**DRAFT DOCUMENT OF WORKING ISSUES
TO ADDRESS
WITH CONDITIONS OR PROFFERS**

Stonewall Secure Business Park, SPEX-2008-0068 (Office, administrative, business and professional, which do not meet the criteria contained in Section 4-503(G) and Floor area ratio up to 0.60 for office and data center uses), SPEX-2008-0069 (Water storage tank), SPEX-2008-0070 (Water treatment plant), SPEX-2010-0018 (Firearm range, archery range, indoor), and SPEX- 2010-0034 (Utility Substation, Transmission)

SUBJECT: ZMAP 2008-0017, Stonewall Secure Business Park (SSBP), 3rd Referral
SPEX 2008-0068, SSBP - Office & 0.6 FAR, 3rd Referral
SPEX 2008-0069, SSBP - Water Storage Tank, 3rd Referral
SPEX 2008-0070, SSBP - Water Treatment Plant, 3rd Referral
SPEX 2010-0018, SSBP - Indoor Firearm Range, 3rd Referral
SPEX 2010-0034, SSBP - Utility Substation, Transmission, 1st Referral
CMPT 2010-0014, SSBP - Utility Substation, Transmission, 1st Referral

FIGURE
13

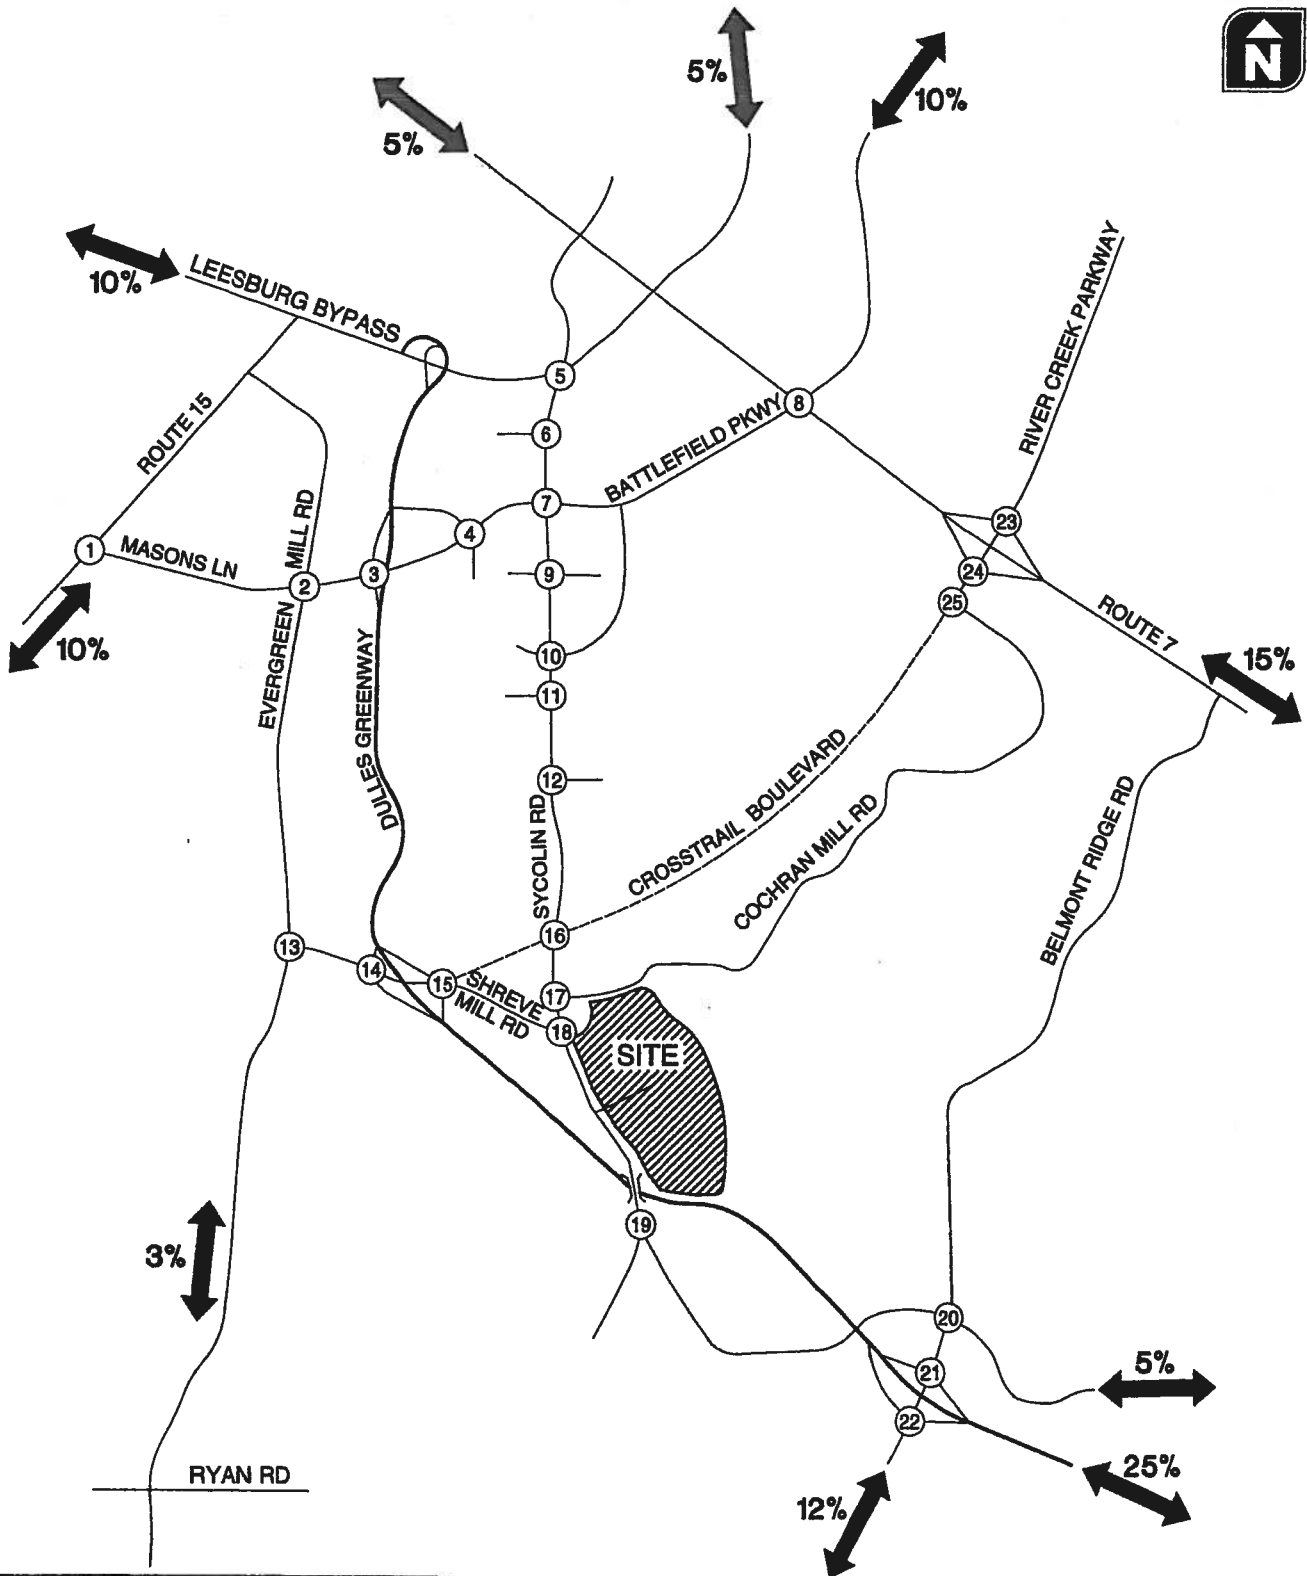
Figure 13 in the Applicant's traffic study (*Attachment 16*) estimates trip distribution information for all phases based on existing travel patterns and origin/destination patterns. The site traffic is distributed with 43% of the traffic approaching from the north and west, 3% approaching from the southwest and 42% approaching from the east and southeast, and 15% approaching from the northeast.

2 OF 7

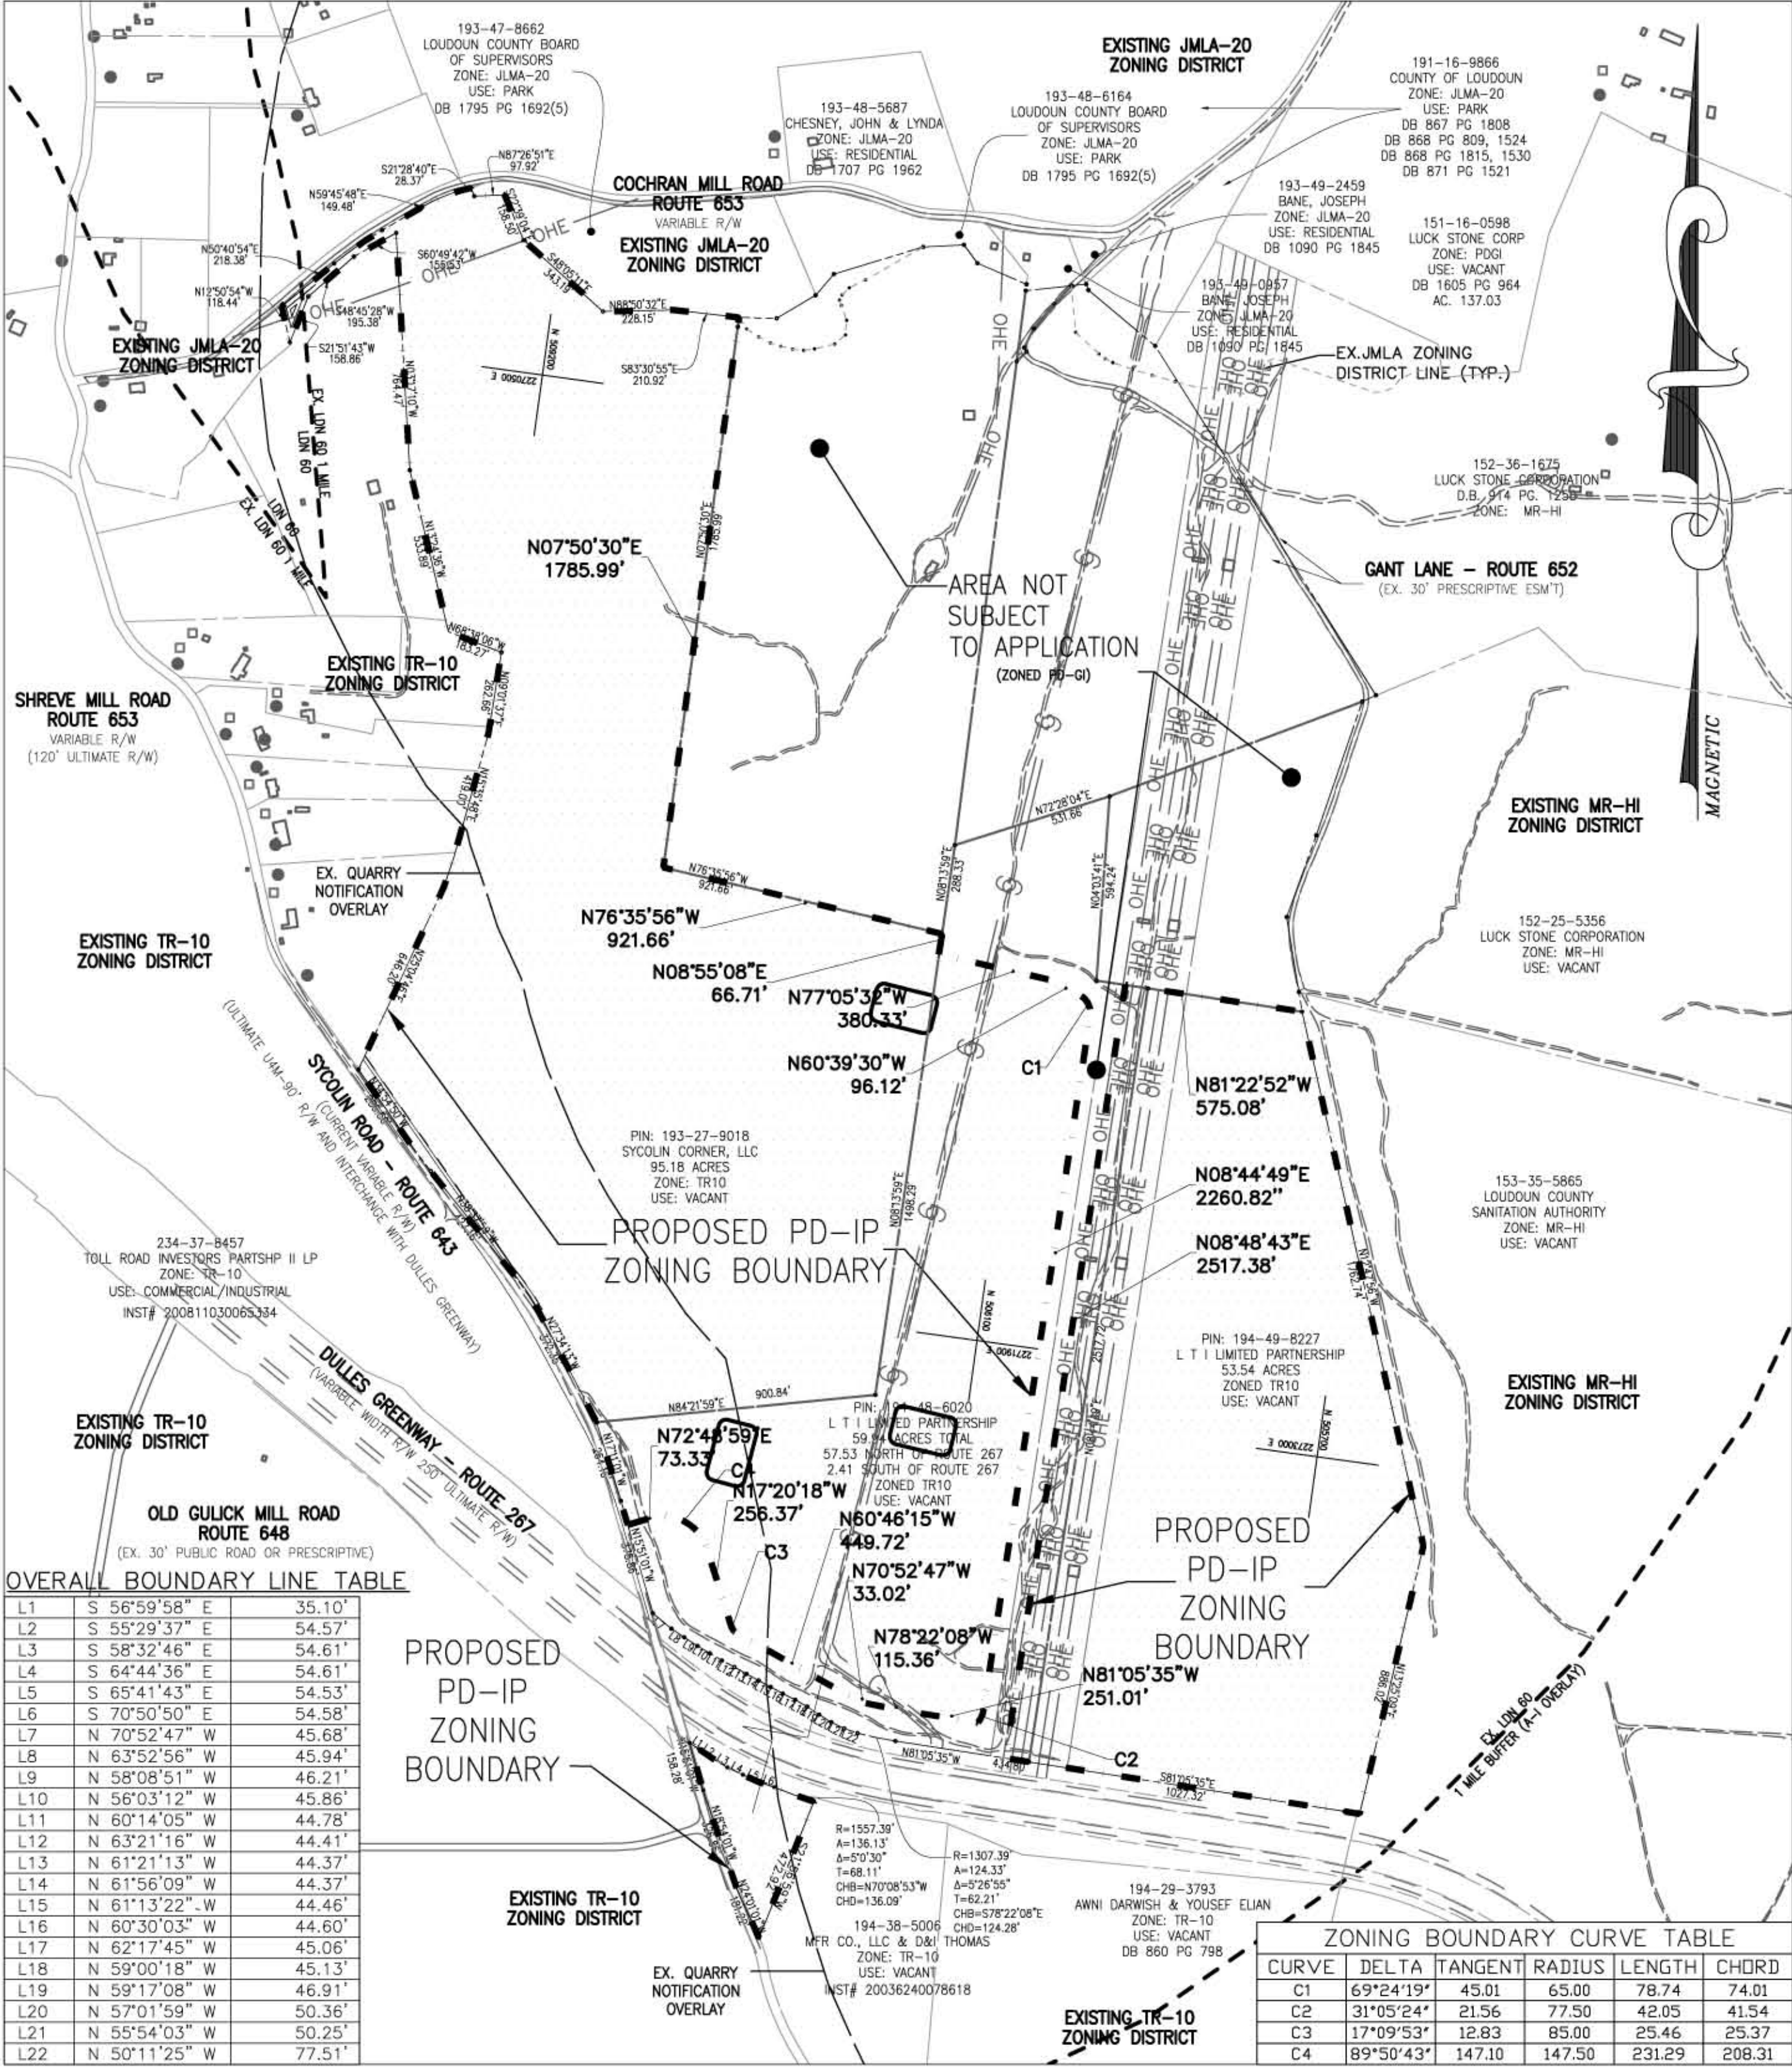
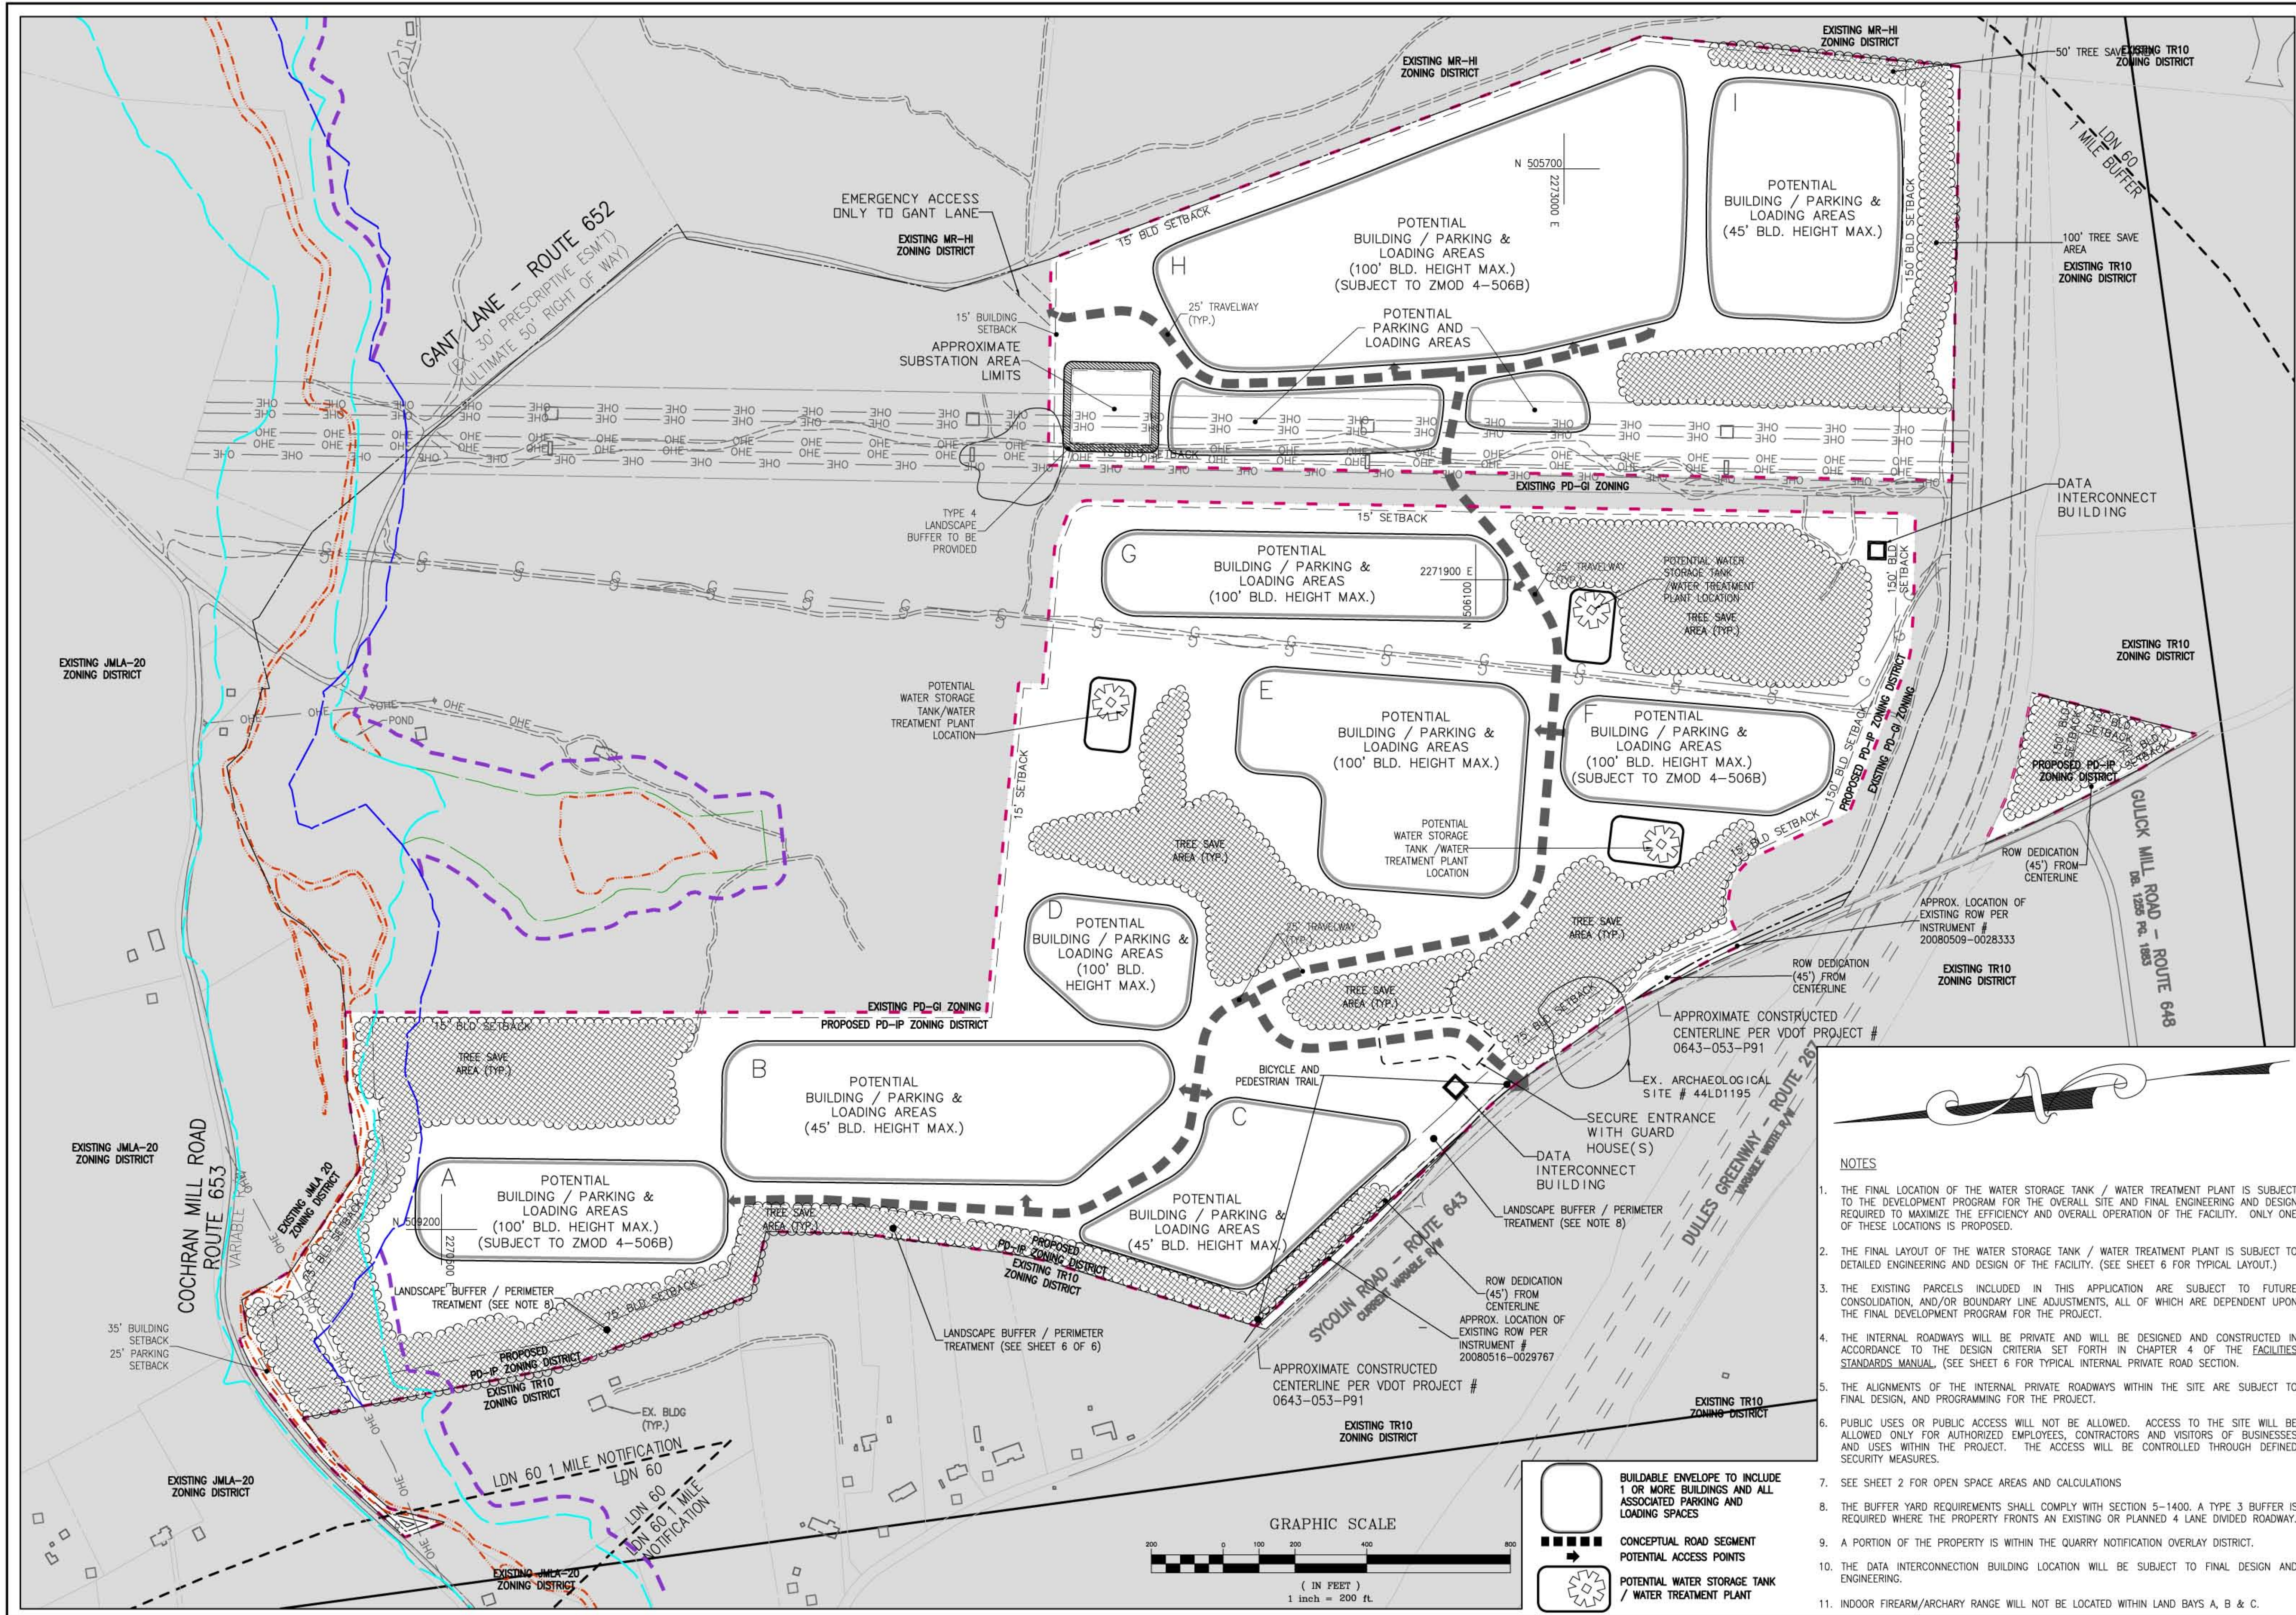
7. In regard to sheet 2 and as noted in the proffer comments above, the acreages (overall and individual parcel) in the notes, tables, and plat on sheet 2 are not consistent with the statement of justification or the proffer. Remove all discrepancies regarding the stated acreages and revise the calculations if necessary.

8. Under Concept Plan notes on sheet 2, delete note 1. The zoning tabulations table does not provide the type, location and nature of land use or building type information.

9. Under Concept Plan notes on sheet 2, in note 4, correct the title of the reference sheet so that it matches sheet 5.
10. Under Concept Plan notes on sheet 2, in note 8.B., remove the reference to structures. Change "vicinity plan" to "vicinity map."

11. Under Concept Plan notes on sheet 2, delete note 11.
12. Under the Information Tabulation Notes on sheet 2, delete note 4. Or, change the phrase "all minimum requirements" to "lot and building requirements." (Prior comment D.2.)

13. Under the open space map on sheet 2, the note references "net land area." However, there is no indication as to what is excluded to reach the net land area. Revise this note to reference "buildable area" to be consistent with the Zoning Ordinance.

8. **Section 4-1400, AI-Airport Impact Overlay District.** Revise note 12 (existing conditions map) on sheet 2 to indicate that a small portion of parcel 60/41 is within the LDN-60 contour, not that the whole property is within the LDN-60 contour. (Prior comment B.34.)

A note has been added to Concept Plan Sheet 2 to state that the utility substation is subject to Section 5-616.

Note 11 on Sheet 2 has been deleted.
